## ST. TAMMANY PARISH

**Addendum No.:** 1  
**Bid#:** 24-22-2  
**Project Name:** Tchefuncte Habitat Restoration  
**Bid Due Date:** Thursday, June 27, 2024

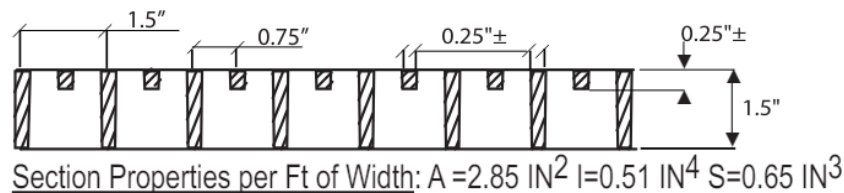
### 6. Plans-

All references to Mesh Grate Decking throughout the plans shall be revised to 1-½ inches in thickness as shown below:

GRATING, Section 2.3 MOLDED FRP GRATING- **DELETE** subsection H in its entirety and replace with the following:

- H. Mesh Configuration: 1-½" square mesh bottom, 3/4" square mesh top, with a tolerance of plus or minus 1/16" mesh centerline to centerline. Top surface meets ADA requirements.
